SUBJECT: Forwards responses to NRC questions 251.2, 251.3, 251.5 & 251.7 re fracture toughness. Responses will be incorporated into FSAR in future amend.

Subject: Palo Verde Nuclear Generating Station
(PVNGS) Units 1, 2 and 3
Docket Nos. STN-50-528/529/530
File: 81-056-026; G.1.10

- References:
- A) Letter from R. L. Tedesco, NRC, to E. E. Van Brunt, Jr., dated August 13, 1981; Subject: Request for Additional Information and Draft SER Inputs (Materials Engineering Branch) (MTEB)
 - B) Letter from EEVB Jr. to R. L. Tedesco, dated August 28, 1981, ANPP-18793

ARIZONA NUCLEAR POWER PROJECT
 PALO VERDE UNIT NO. 1
 R.V. BELTLINE REGION

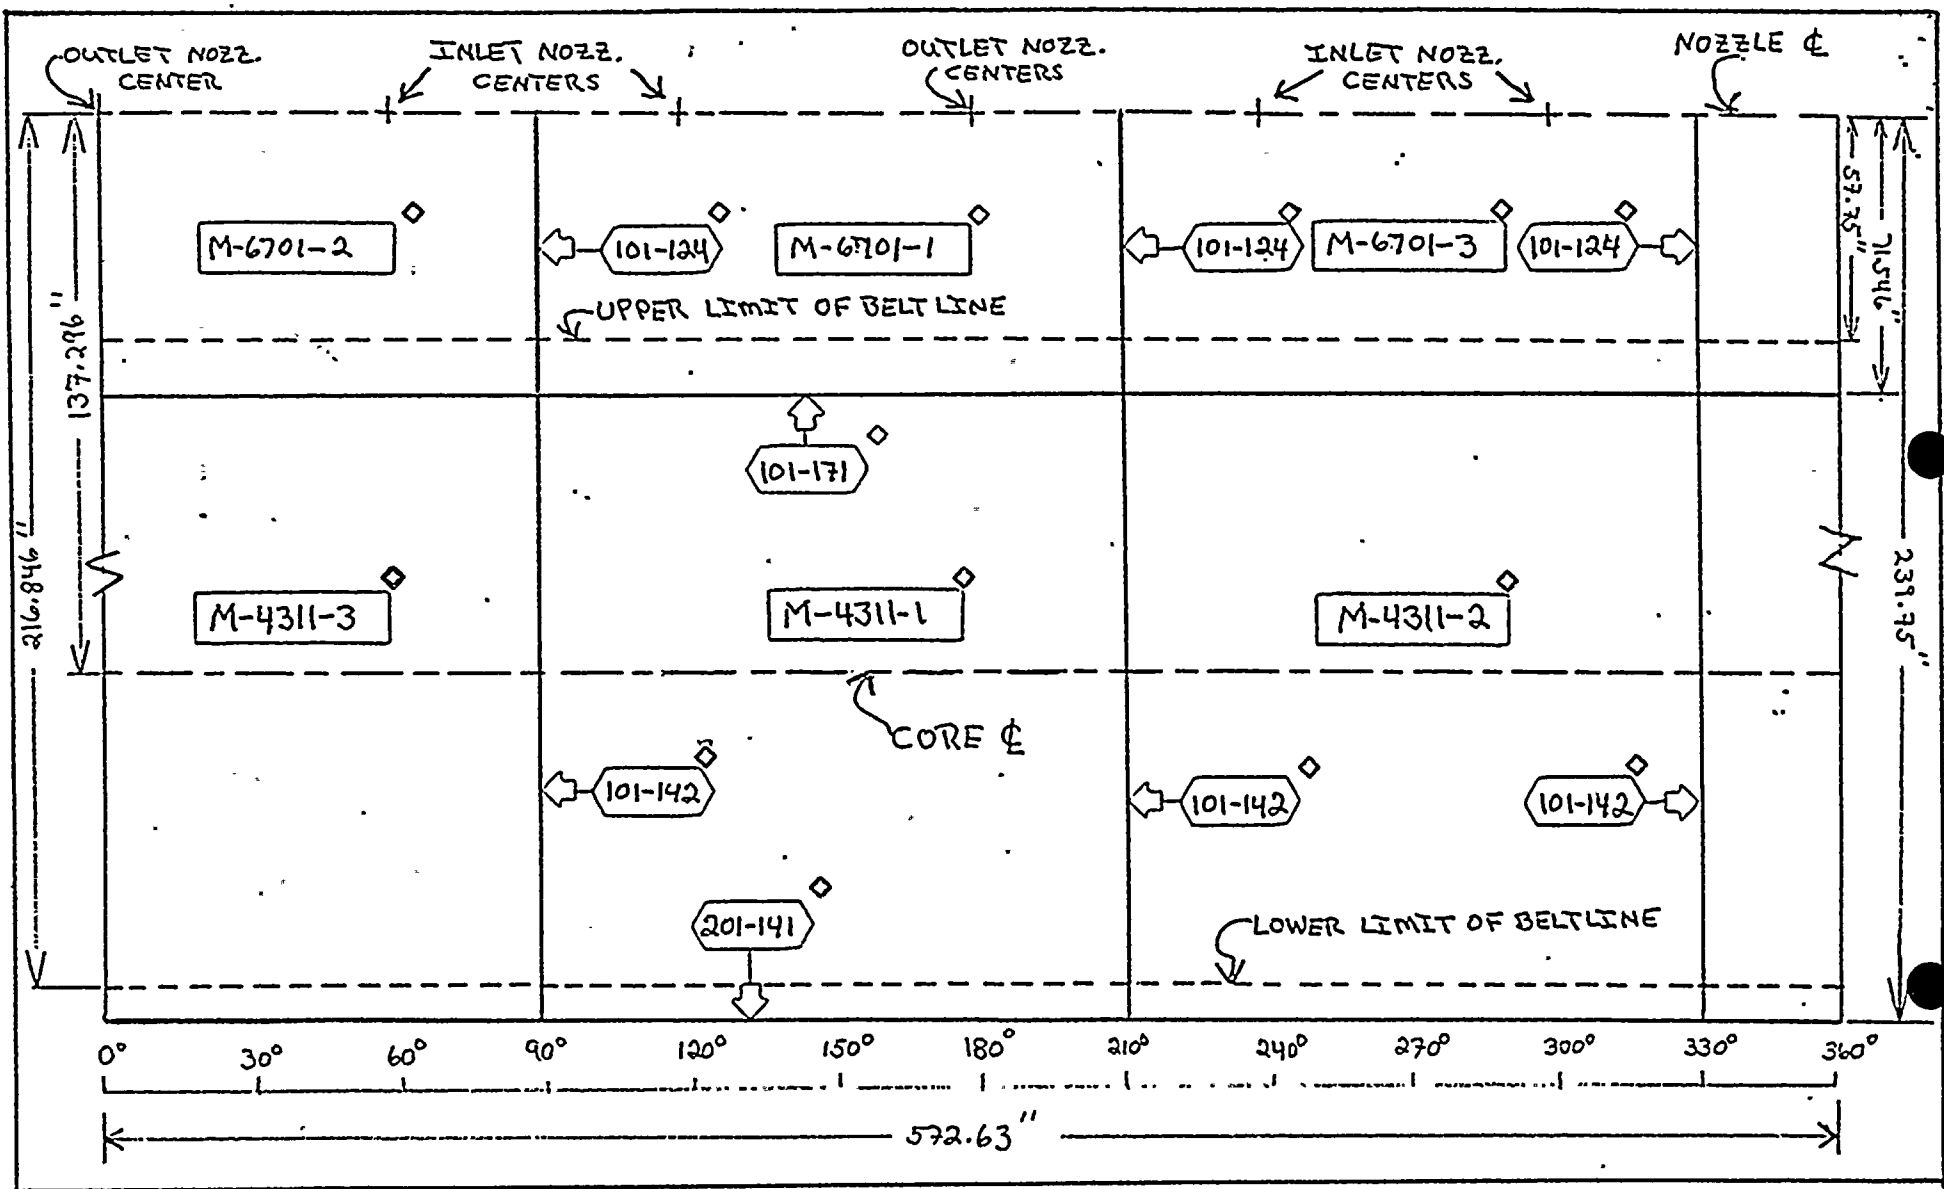
Question 251.2 (a) "To demonstrate compliance with the fracture toughness requirements of paragraph IV.A.1 of Appendix G, 10 CFR Part 50:

Provide a schematic of the reactor vessel showing all welds, plates and/or forgings in the beltline. Welds should be identified by shop control number, weld procedure qualification number, the heat of filler metal, and type and batch of flux. Provide the chemical composition for these welds (particularly Cu, P, and S content). Identify material specification, type and grade of all base metal."

- (a) A schematic of the reactor vessel beltline region showing weldseam numbers and plate code numbers is shown in figure 1 of this document.
- (b) Weld procedure qualification numbers and associated fracture toughness data from weld procedure qualification tests for the reactor vessel will be provided in the ~~WRG~~ FSAR (Table 5.2.3-4) by 10/1/81.
- (c) Weld metal used in the fabrication of the R.V. beltline and its fracture toughness properties from weld metal certification tests will be provided in the ~~WRG~~ FSAR (Tables 5.2.3-3A) by 10/1/81.
- (d) For chemical composition of welds in the R.V. beltline, see Table 5.3.1-2 of ~~the~~ FSAR.
- (e) For chemical composition of plates in the beltline, see Table 5.3.1-1 of ~~the~~ FSAR.
